**LEBANON PLANNING BOARD
JUNE 8, 2026 - 6:30 PM
COUNCIL CHAMBERS, CITY HALL OR
REMOTE VIA VIRTUAL PLATFORM
LEBANONNH.GOV/LIVE**

RE: June 8, 2026 Regular Meeting - Agenda Item 3.B
Site Plan Application for 63 Evans Drive (Tax Map 78, Lot 40-100)

From: Tim Corwin
Sent: Thursday, May 14, 2026 9:16 PM
To: Dan Nash; 'Johanna Cicotte'
Cc: Brian Vincent; Crystal Taplin; Nathan Reichert
Subject: 63 Evans Dr_PB2026-28-SPA_Staff Comments
Attachments: 2000 Site Plan NOAs and Approved Plan Set.pdf

PLANNING STAFF COMMENTS (PB2026-28-SPA) (please note that (a) parenthetical references are to Section numbers of the Lebanon Site Plan Review Regulations, and (b) comments are arranged in general categories, i.e. the order of comments is not intended to denote importance)

X-1 EXISTING CONDITIONS	EVANS DRIVE SPE
	PROJECT NO.
	SHEET NO.
	DATE

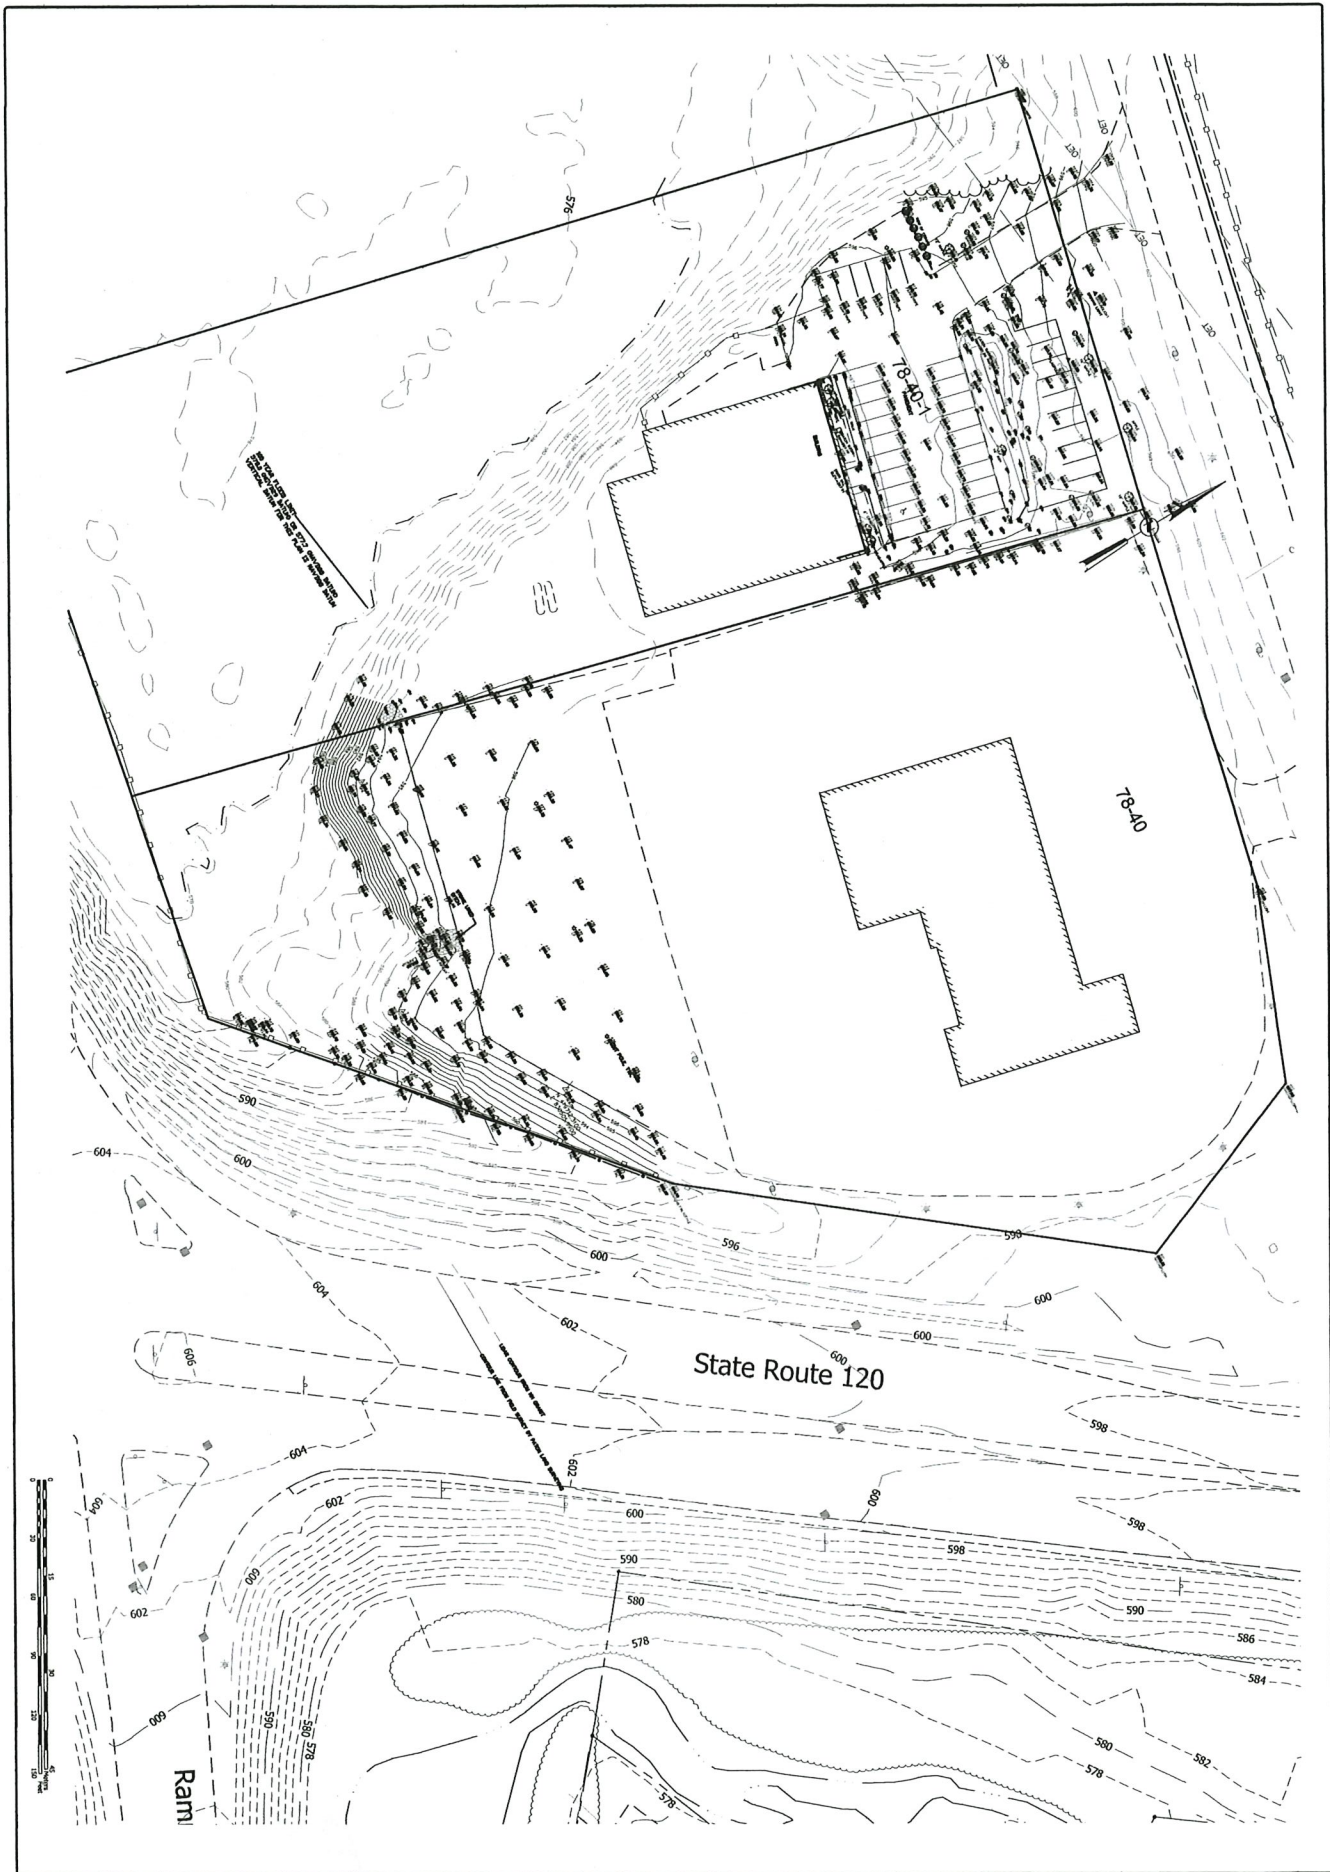
29. Add location of wetlands to the plat. (9.5.A.7)
30. Add to the plat the name, seal, and business address of the Certified Wetland Scientist who performed the wetlands delineation. (9.5.A.3 and 9.5.A.7)
31. Clearly depict those natural and man-made features that are to be removed, retained, or altered. (5.1.E.8)

SITE PLAN AMENDMENT

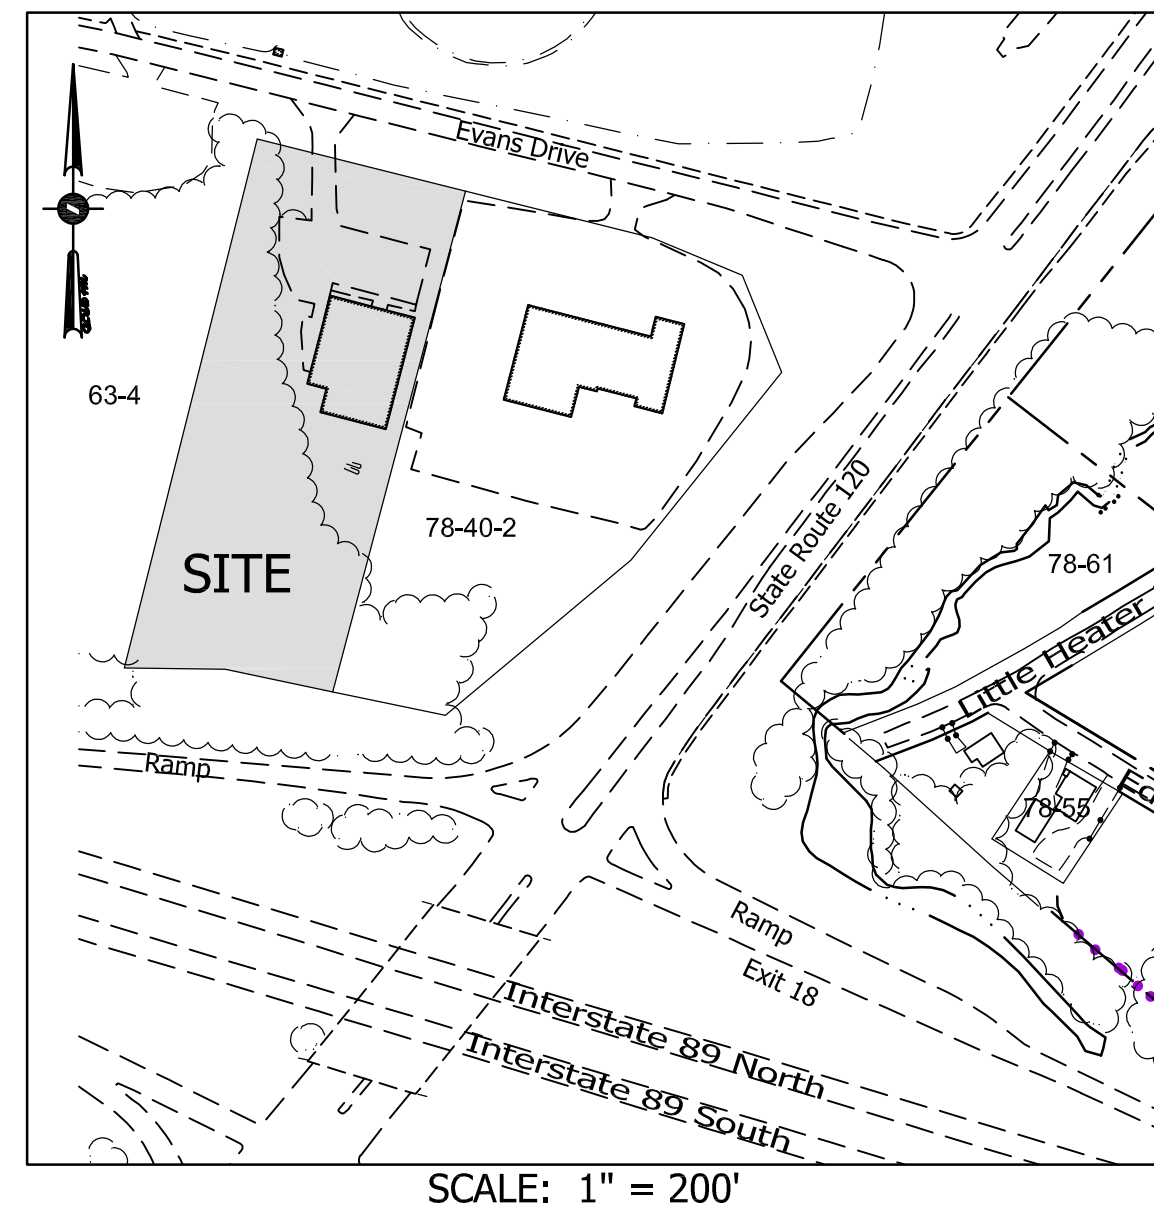
21. Add the name and business address of the Certified Wetlands Scientist who performed the wetlands delineation. (5.1.E.3)
22. “Zoning Comparison” Table:

- a. Identify:
 - i. the maximum number of permitted parking spaces, and provide calculation (5.1.E.4.e.5)
 - ii. the number of existing & proposed short- & long-term bicycle storage spaces (5.1.E.4.e.6)

- v. the proposed use (5.1.E.4.e.10) – *“animal hospital” appears to be the existing use of the property and the proposed use*
 - vi. add a note that the “office” category is being used for purposes of calculating the minimum required parking per Section 607.1.A of the Zoning Ordinance (which provides that, “For uses not listed in the table, the minimum requirement shall be that of the closest similar use as determined by the Zoning Administrator);

- b. Change the number of minimum required spaces from 40 to 39 (fractional numbers are rounded down per the Table of Minimum On-Street Parking Requirements – Sec. 607 of the Zoning Ordinance)

23. Identify the site plan that the proposed “site plan amendment” is amending.
24. Add note identifying the floodplain permit number and date permit was issued/approved.

25. Add a note indicating that the plan is approved pursuant to the City of Lebanon Site Plan Review Regulations last revised March 11, 2026, and the City of Lebanon Zoning Ordinance last revised March 23, 2026.
26. Add Planning Board application number (PB2026-28-SPA) to the title block or as a plan note.
27. Provide date and description of revisions made. (9.5.A.1)

SITE PLAN
FOR
SAVES ANIMAL HOSPITAL
IN
LEBANON, NH

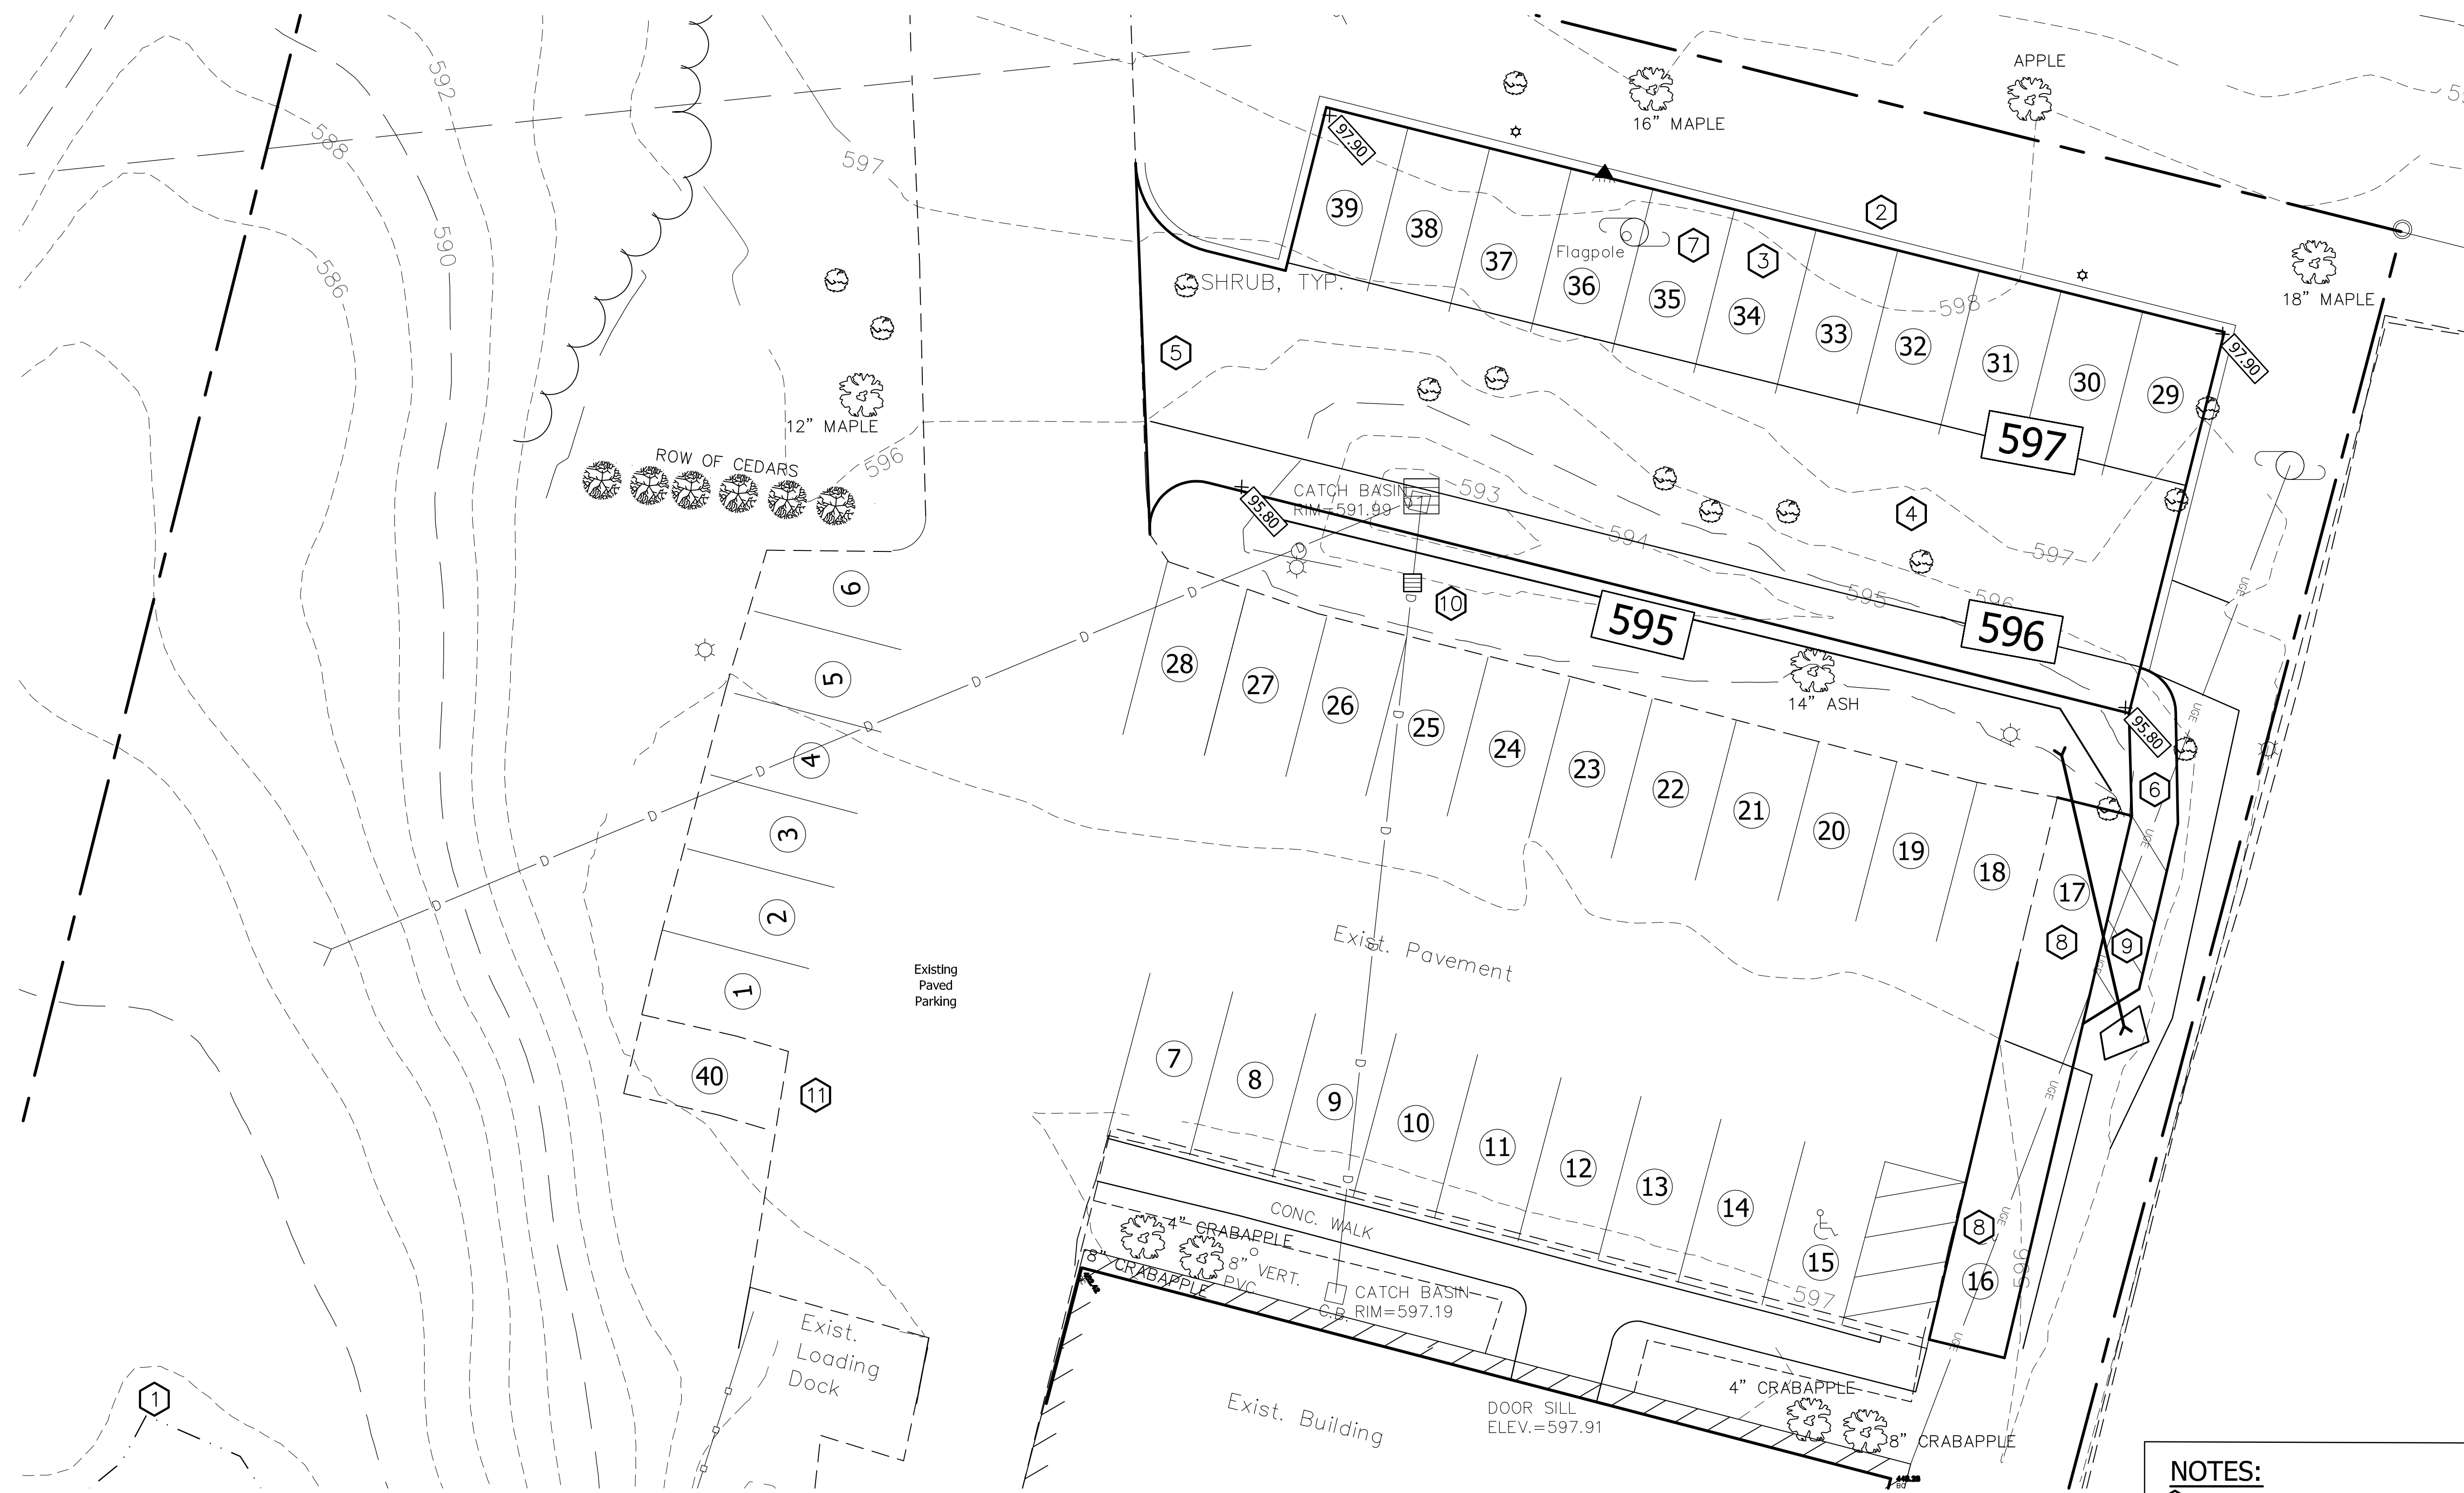
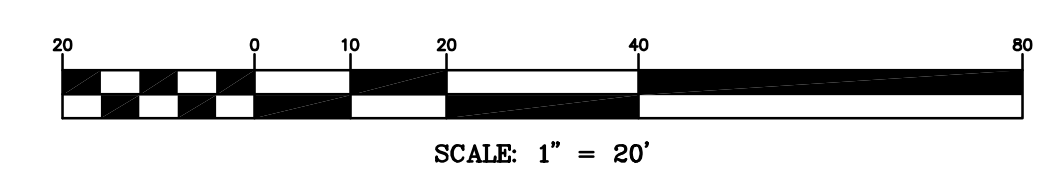
32. The plan is extremely cluttered, confusing, and difficult to read. There are multiple aspects of the plan that are unreadable, unlabeled, confusing, and unclear as to what's existing, what's proposed to be constructed, and what's proposed to stay or to be removed. *Staff is unable to verify with confidence what is being proposed and whether the improvements are fully compliant with the Site Plan Review Regulations.* For the benefit of the Planning Board members and the site plan review process, please provide a site plan that primarily shows the above-ground proposed physical improvements that is readable and is without any unnecessary or confusing information.

- a. Provide a legend and and/or labels that more clearly identify the different lines and markings, and remove unnecessary layers - including the existing conditions - to make the plan less confusing and more readable.

33. Add the proposed site lighting.
34. A light fixture is shown along the northern edge of the proposed parking lot but is not also shown on the lighting plan. Please clarify.
